Access Compliance Report

Public Rights-of-Way

(Curb Ramps)

Intersection ID: 47585	Main Street: EVANTON_LOCH_RD	Cross Street: SEAMILL_RD	Location: NW
ADA ID: AC320B53B8E3	Ramp Type: Perp	Initial Pass/Fail: Pass	Overall Compliance: No
Codes/Mitigation Info/Possible Solution		Field Measurements/Component Compliance	
Severity Score: 0.25

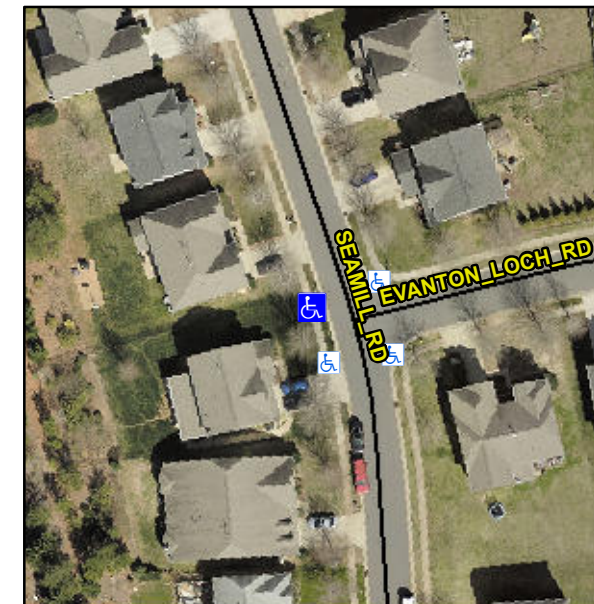
**Remove & Replace Entire Ramp.
Remove & Replace Gutter.**

**R304.2.2-Perp, R304.3.2-Para,
R305.2, R304.5.3**
